# Access Compliance Report

## Public Rights-of-Way

### (Curb Ramps)

Intersection ID: 9403	Main Street: EUREKA_ST	Cross Street: RUSH_WIND_DR	Location: SW
ADA ID: 66BF3185A172	Ramp Type: Para	Initial Pass/Fail: Fail	Overall Compliance: No
Severity Score: 50			
Codes/Mitigation Info/Possible Solution		Field Measurements/Component Compliance

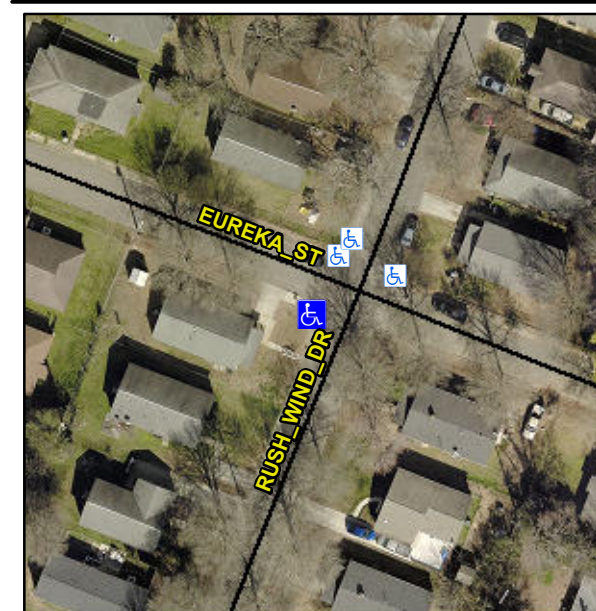
**NO CURB LINE, RT RP < 5%**

**R304.3.2, R304.5.3**

Compliance	Description	Data	Compliance	Description	Data
N/A	Ramp Length LT (in)	62.0	N/A	Ramp Length RT (in)	44.0
Yes	Ramp Width LT (in)	65.0	Yes	Ramp Width RT (in)	64.0
No	Ramp Slope LT (%)	14.6	Yes	Ramp Slope RT (%)	2.9
No	Ramp XSlope LT (%)	10.5	No	Ramp XSlope RT (%)	8.4
N/A	Landing Length (in)	N/A	N/A	DWS Provided?	N/A
N/A	Landing Width (in)	N/A	N/A	DWS Contrast?	N/A
N/A	Landing Slope (%)	N/A	N/A	DWS Length (in)	N/A
N/A	Landing X Slope (%)	N/A	N/A	DWS Full Width?	N/A
N/A	Landing Curb? (Y/N)	N/A	N/A	DWS Offset (in)	N/A
N/A	Shared Landing?	N/A			
N/A	Gutter Ponding?	N/A	N/A	Gutter Slope (%)	N/A
N/A	Gutter Lip Ht (in)	0.5	N/A	Gutter X Slope (%)	N/A
N/A	Painted X Walk1?	No	N/A	Painted X Walk2?	N/A
	X Walk 1 Direction	To NE		X Walk 2 Direction	N/A
N/A	X Walk 1 Width (in)	N/A	N/A	X Walk 2 Width (in)	N/A
	X Walk 1 Slope (%)	1.6		X Walk 2 Slope (%)	N/A
	X Walk 1 X Slope (%)	2.8		X Walk 2 X Slope (%)	N/A
N/A	Ramp inside XWalk1?	N/A	N/A	Ramp inside XWalk2?	N/A

**Remove & Replace Entire Ramp.**
